# **DESIGN REVIEW BOARD**

# Staff Report

Florida Cancer Specialists

DOS2019-E003

Exhibit A - Sheet 1 of 2

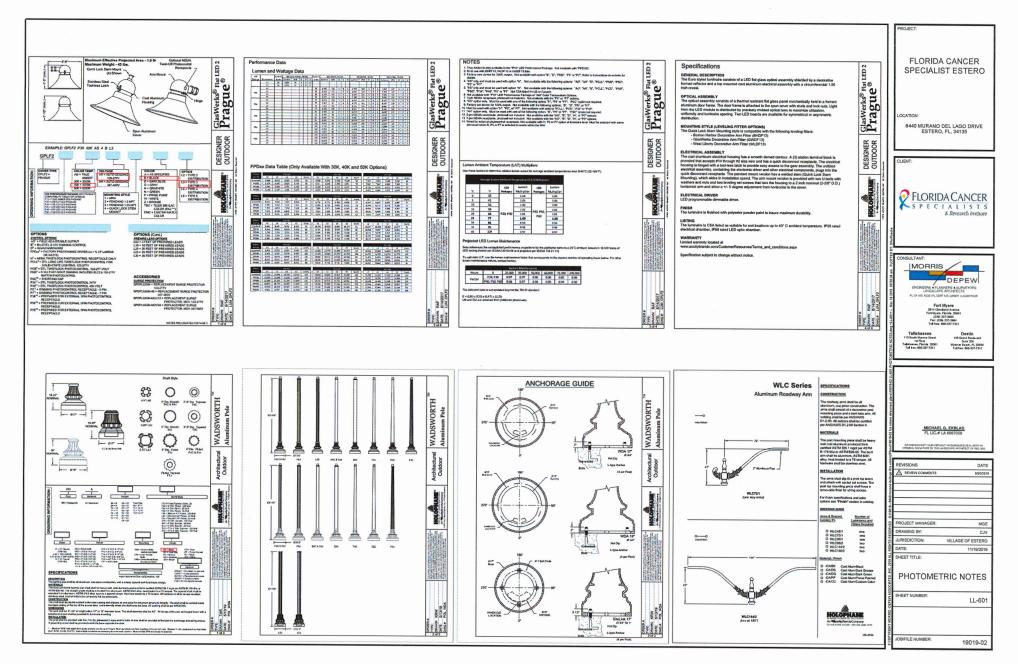
Consistent with Land Development Code Section 34-625, site lighting is provided by architectural LED luminaire fixtures mounted at 15 feet on poles, and wall mounted fixtures, all bronze color, which produce an average of 2.2 foot-candles (fc) illumination in the main parking lot with no light spillage (0 fc) measured at 10 feet onto the adjacent property. Details of the light poles and fixtures are provided (see Exhibit A).
